# **MONITORING YEAR 1 ANNUAL REPORT FINAL**

## **HUNTSMAN MITIGATION SITE**

DMS Project No. 100123

RE: Huntsman Draft MY1 Report Review  
Yadkin River Basin – CU# 03040102  
Wilkes County  
DMS Project ID No. 100123  
Contract # 7891

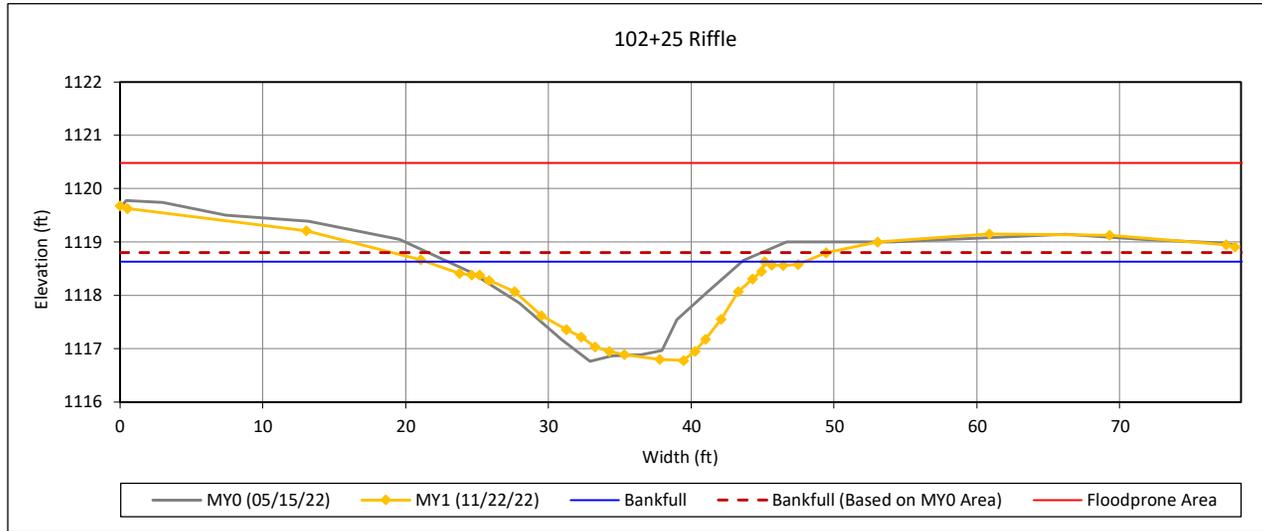
**DMS' Comment: Cross Section 1 and 2 Plots: Recommend adding note that these two cross sections are located in an area that was repaired in MY1.**

*Wildlands' Response: Cross-sections 1 and 2 have been updated accordingly.*

XS 1 is located in an area that was repaired in MY1.

Figure 3.1 Current Condition Plan View  
 Huntsman Mitigation Site  
 Yadkin River Basin (03040102)

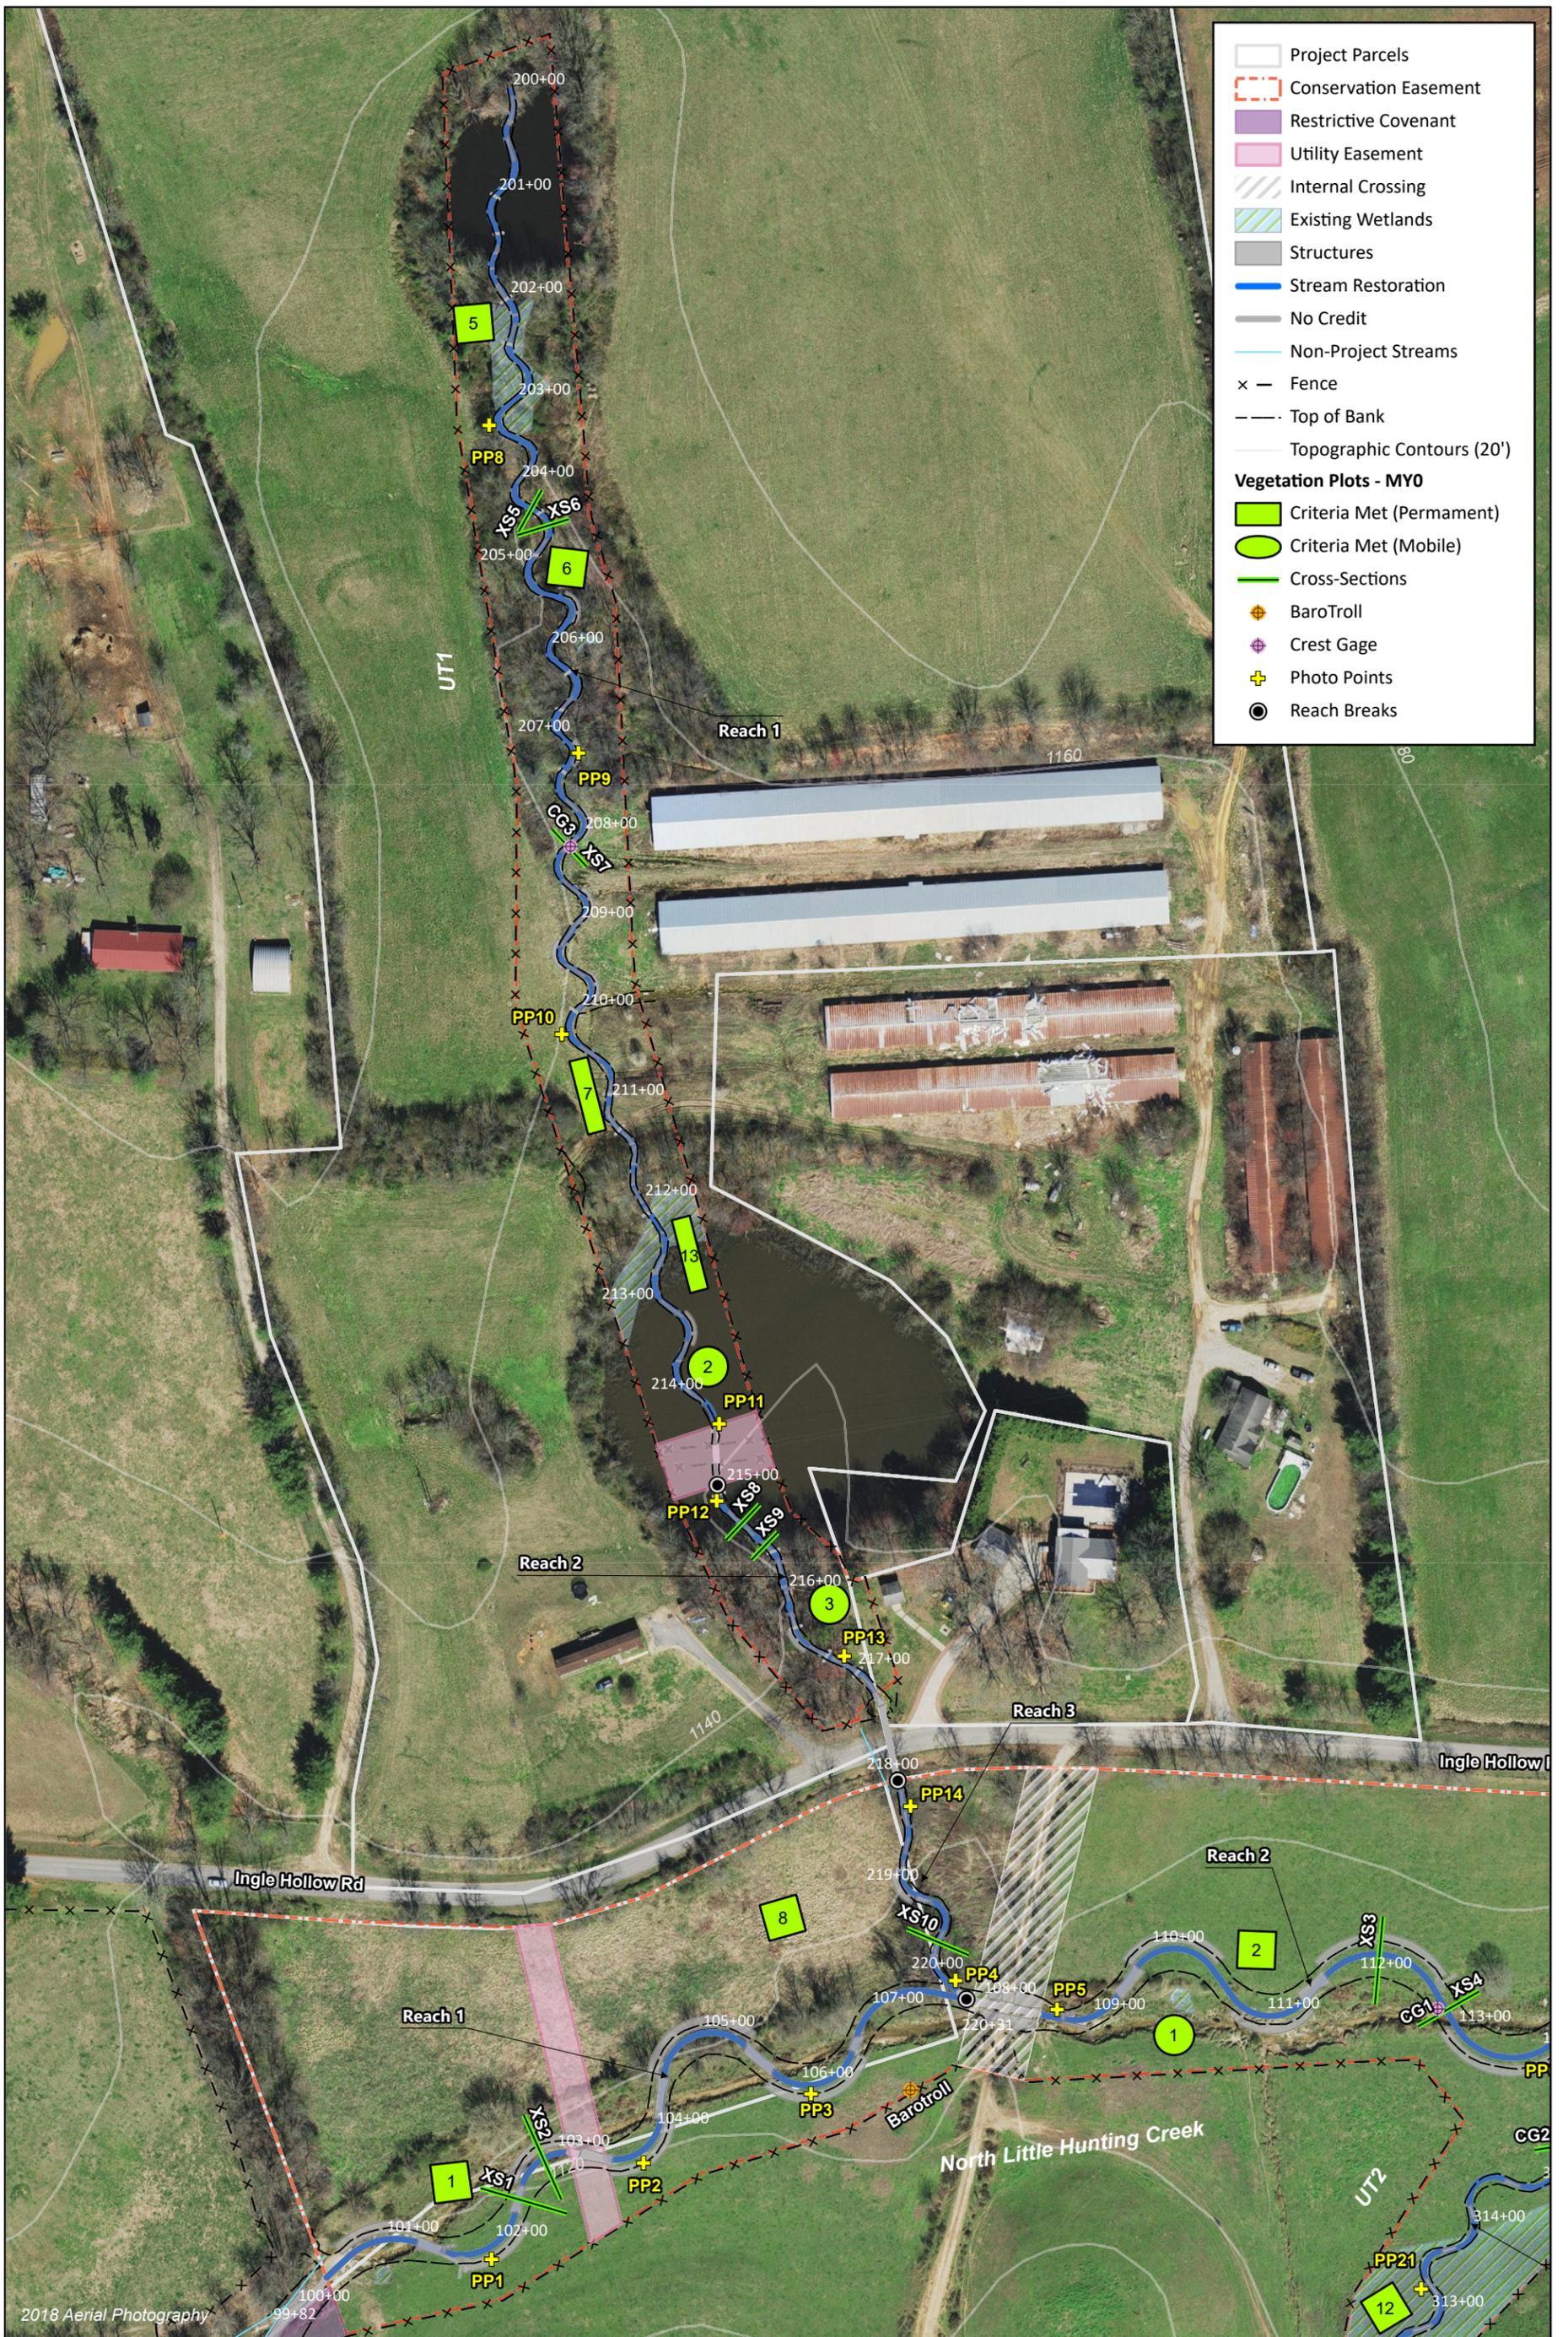
4. Since a permanent veg plot was shown in the UT1 lower pond bottom in both draft and final mitigation plan monitoring figures, DWR did not require one in our review comments. However, since that veg plot has been changed to a mobile plot, DWR is now requiring a permanent veg plot within the UT 1 lower pond bottom.

7. Please add stream and reach labels to the CCPV Figures 3.1 and 3.2.

7. *Please add stream and reach labels to the CCPV Figures 3.1 and 3.2.*

**Wildlands Response:** A permanent vegetation plot (VP13) has been added along UT1 in the lower pond bottom, and vegetation data will be collected with MY1 monitoring. See Figure 3.1 for the location of the added permanent vegetation plot.

**Wildlands Response:** Stream and reach labels have been added to the CCPV Figures 3.1 & 3.2. Copies of the revised figures are attached.
